[Docket No. FAA-2012-0415; Directorate Identifier 2008-SW-065-AD; Amendment 39-17865; AD 2014-12-04]

Airworthiness Directives; Bell Helicopter Textron, Inc. (BHTI) Helicopters

ACTION: Final rule.

Figure 1 to Paragraphs (f)(2)(ii) and (f)(4)(ii)
Inspection of Main Rotor Hub Grip Tangs

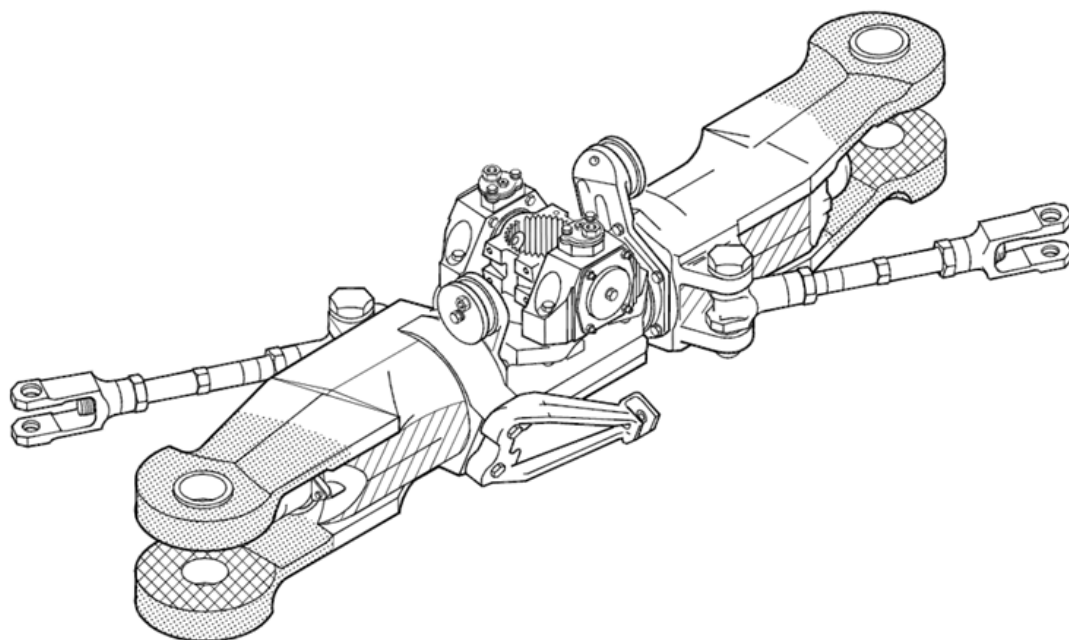
(ii) Using a 10-power or higher magnifying glass, visually inspect the exposed surfaces of the upper and lower tangs of each grip for a crack. Pay particular attention to the lower surface of each lower grip tang from the main rotor blade bolt-bushing flange to the leading and trailing edge of each grip tang as depicted in Figure 1 to Paragraphs (f)(2)(ii) and (f)(4)(ii) of this AD.

(ii) Inspect each grip buffer pad on the inner surfaces of each grip tang for delamination as depicted in Figure 1 to Paragraphs (f)(2)(ii) and (f)(4)(ii) of this AD. If there is any delamination, remove the buffer pad and inspect the grip surface for corrosion or other damage.
